Regional Council submission on Plan Change 2 – to rezone 23 & 45 Keepa Road

Regional Council Submission on Private Plan Change 2 to the Whakatāne District Plan - Keepa Road Structure Plan (12 April 2018)

Regional Council - Indicative Structure Plan Keepa Road (Appendix 2.6.4)

Indicative Structure Plan Keepa Road

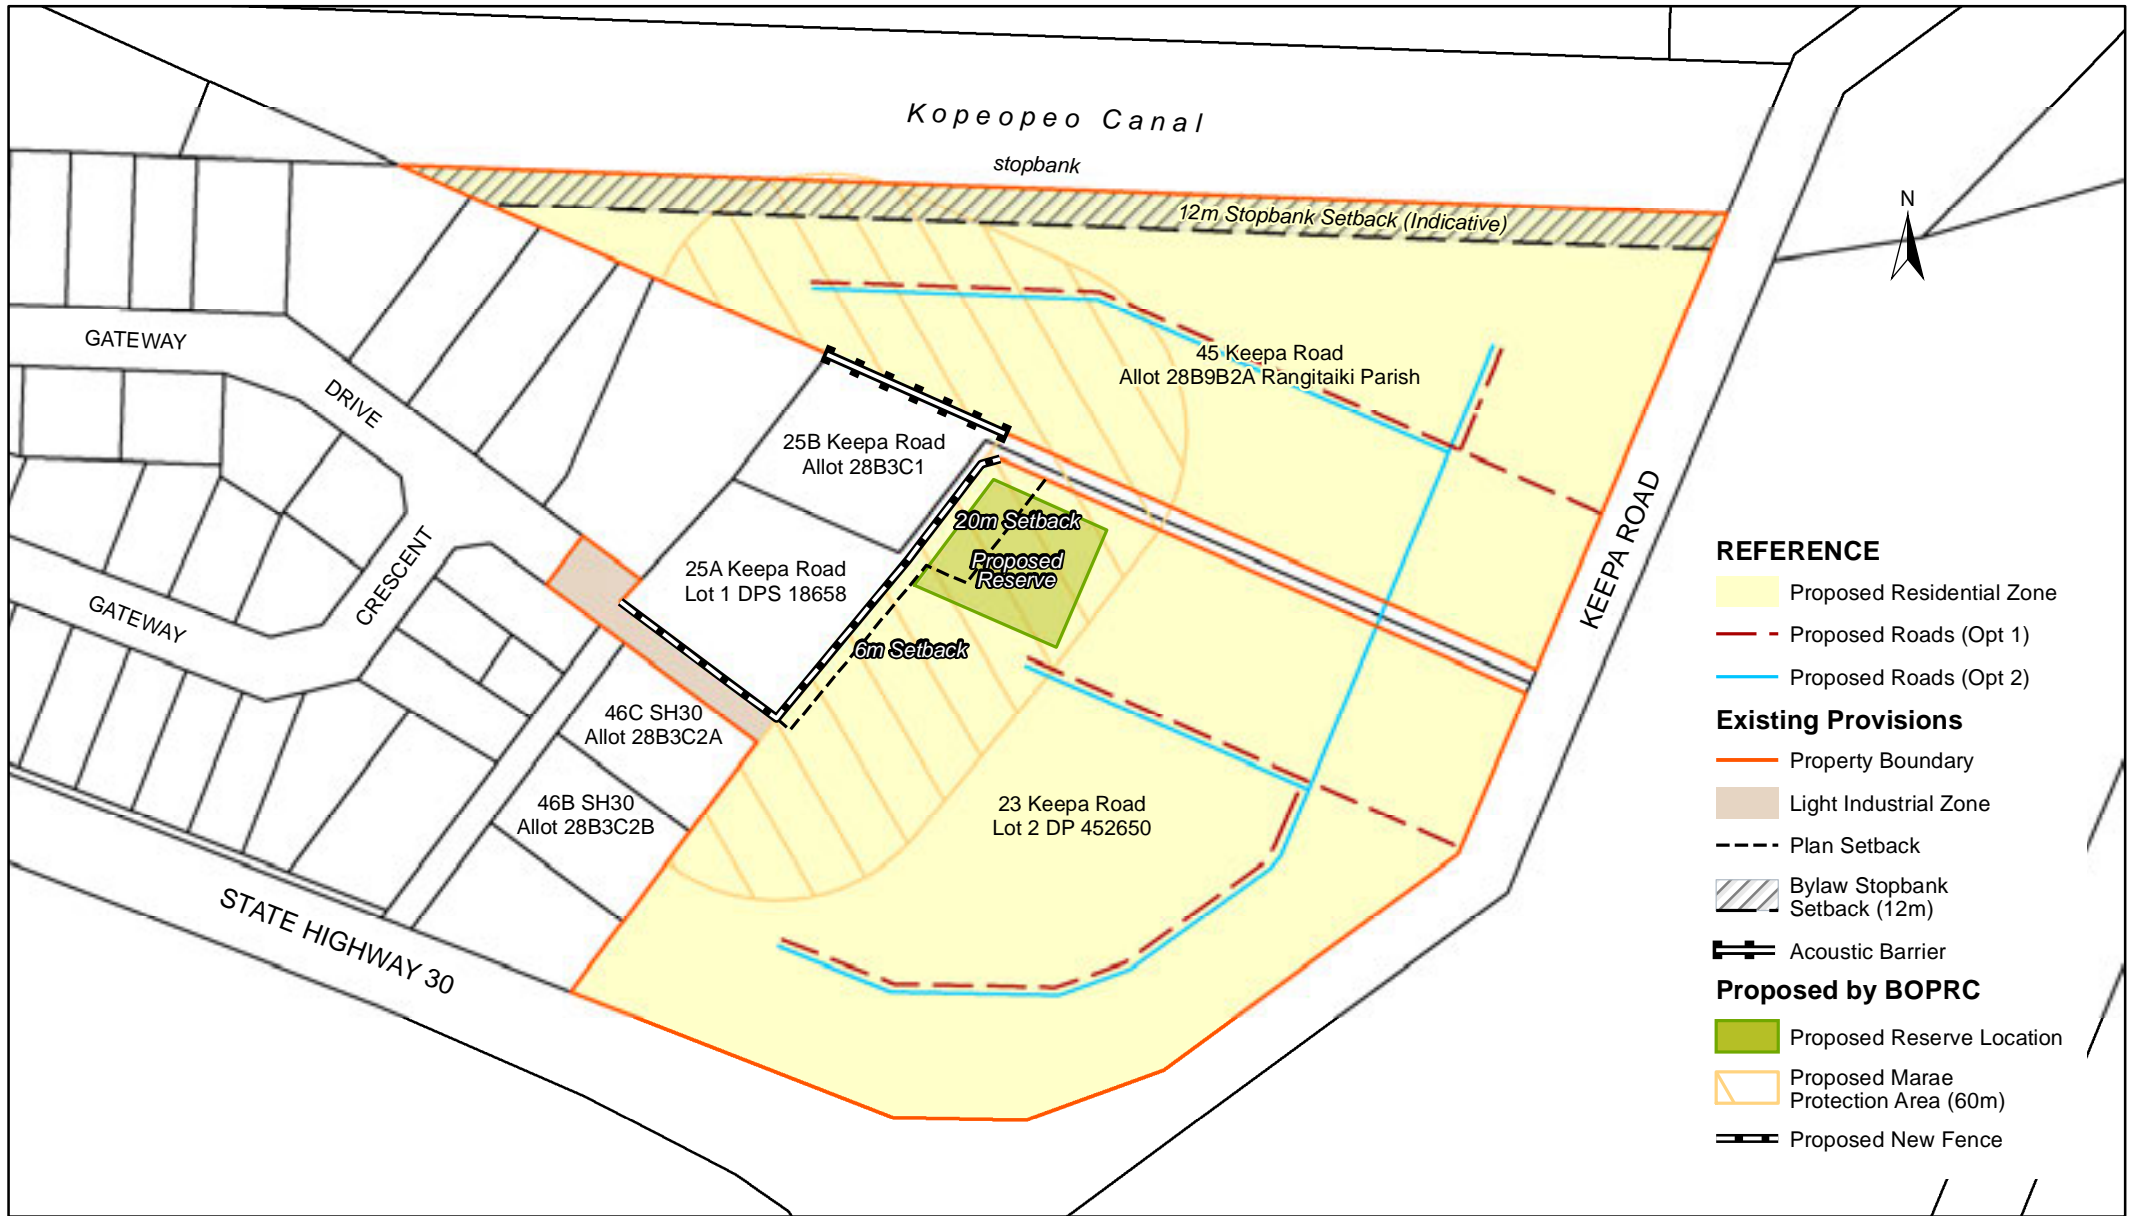
Plan Reference	Comments	Support/Oppose or Seek Amendments	Regional Council requests the following decisions
New Rule 2.2.2.5 Appendix 2.6.4 Keepa Road Structure Plan	<p><i>Demonstrates how provision has been made for public transport cycleways and pedestrian connections and roading connectivity with adjacent blocks of land.</i></p> <p>As stated in the second submission point this has not been provided as part of this Plan Change.</p>	<p>status and an additional discretionary rule is requested for subdivision/ development within a new 'Marae Protection Area' to address reverse sensitivity effects on the Marae (see relevant submission points for further discussion on this).</p>	<p><u>activity.</u></p> <p>Insert a new Rule 2.2.2.5 to read:</p> <p><u>Non-compliance with Rule 2.2.2.4 - Keepa Road Structure Plan shall be a Discretionary Activity.</u></p> <p>Insert as Appendix 2.6.4 Keepa Road Structure Plan the attached 'Indicative Keepa Road Structure Plan' (Appendix 1).</p>

Rule 2.3.4.1 Rule 2.4.5.1 New Rule 2.5.1 Keepa Road Structure Plan Appendix 2.6.4 New Stopbank Setback	<p>The Plan Change (p16) identified the site as being <i>potentially affected by flooding hazards, including local stormwater flooding as well as inundation resulting from overtopping of the Kopeopeo Canal or the Whakatāne River stopbanks... The site also adjoins the Kopeopeo Canal which is part of the Rangitāiki Drainage Scheme.</i></p> <p>The indicative subdivision plans (Appendix 4) illustrate proposed development up to the northern boundary of 45 Keepa Road adjacent to the Kopeopeo Canal's stopbank.</p> <p>'Section 3.2 Defences against Water' of the Bay of Plenty Regional Council Floodway and Drainage Bylaw 2008 (the Bylaw, p4) restricts activities including structures and planting of shrubs, hedges, trees and disturbance within 12 meters of the landward side of a stopbank unless written authority is provided by Regional Council.</p>	<p>Seek amendment: Regional Council seeks an amendment to Keepa Road Structure Plan, Appendix 2.6.4 to ensure it illustrates the stopbank setback. An additional criteria is also requested to ensure the Bylaw is considered as part of any development or subdivision.</p> <p>This is a known restriction on development on the site, in an area which is potentially affected by flooding hazards.</p> <p>Regional Council have shown this setback in attached 'Indicative Structure Plan Keepa Road', <i>Appendix 1</i>.</p>	<p>Insert a new assessment criteria under Rule 2.4.5.1 and new Rule 2.5.1 given the earlier request to decline controlled activity criteria in Rule 2.3.4.1. It should read:</p> <p><u><i>obtain any necessary floodway and drainage bylaw authority from the Regional Council.</i></u></p> <p>Amend Appendix 2.6.4 to include a stopbank setback as illustrated in <i>Appendix 1</i> Indicative Structure Plan Keepa Road.</p>

Plan Reference	Comments	Support/Oppose or Seek Amendments	Regional Council requests the following decisions
Structure Plan Appendix 2.6.4 Ponding area	<p><i>area situated in the northwest corner of Allotment 28B9B2A Rangitiaki Parish, overlaid flowpaths along the roads and right of ways, and the piped network, which leads to the existing stormwater pond.</i></p> <p>The proposed ponding area is not illustrated on the Keepa Road Structure Area, Appendix 2.6.4 despite the indicative location being known.</p>	Notwithstanding which, Regional Council requests a new Advice Note to sit beneath assessment criteria for Keepa Road Structure Plan to highlight the importance of managing any discharges from the site. This is particularly important given the potential inundation and flooding issues acknowledged in the Plan Change (p16). The advice note is worded to replicate Advice Note 1 in Rule 13.2.28.8 which applies to the Shaw/ Huna Road Structure Plan.	<p><u><i>drainage scheme requires a bylaw approval under the Bay of Plenty Regional Council Floodway and Drainage Bylaw 2008. The discharge of stormwater to the Kopeopeo Canal also requires a resource consent from the Regional Council.</i></u></p> <p>Amend Appendix 2.6.4 Structure Plan Keepa Road: to include the location of the ponding area.</p>

Plan Reference	Comments	Support/Oppose or Seek Amendments	Regional Council requests the following decisions
	residential living areas including outdoor living spaces.		<p>Amend Keepa Road Structure Plan, Appendix 2.4.6 to include (as illustrated in Appendix 1):</p> <ol style="list-style-type: none"> 1. Existing plan requirements for the acoustic barrier and Marae setbacks. 2. New additions including a reserve within the 20m Marae setback and an extended fence line adjoining the Marae.
Planning Map 105B and 109B			
<p>Map 105B Map 109B Appendix 2.4.6 Keepa Road Structure Plan</p>	<p>Oppose: the rezoning of the site to residential, as requested in the Plan Change and illustrated in Appendix 2 the Keepa Road Structure Plan. The Plan Change requests residential zoning be shown on Planning Maps 105B and 109B as provided for in Appendix 2.4.6 Keepa Road Structure Plan (p1).</p> <p>Regional Council opposes this until such time as adequate information is provided to fully assess the Plan Change, structure plan and appropriate plan provisions.</p> <p>But, should rezoning be considered Regional Council request a 'Te Hokowhiti-a-Tu Marae Protection Area' overlay be shown on district planning map 105B and on the Keepa Road Structure Plan, Appendix 2.4.6 (see Indicative Structure Plan Keepa Road, Appendix 1). This would work in conjunction with proposed new provisions requested above.</p>	<p>Retain Whakatāne District Planning Maps 105B and 109B in their current form without rezoning until sufficient information is provided to support the Plan Change.</p> <p>Alternatively, identify on Map 105B and Appendix 2.6.4 a 'Te Hokowhiti-a-Tu Marae Protection Area' overlay extending no less than 60m outward into the residential zone from the nearest boundary to 25A Keepa Road (Lot 1 DPS 18658) and 25B Keepa Road (Allotment 28B3C1) subject to tangata whenua consultation confirming support for such an approach through a Cultural Impact Assessment.</p>
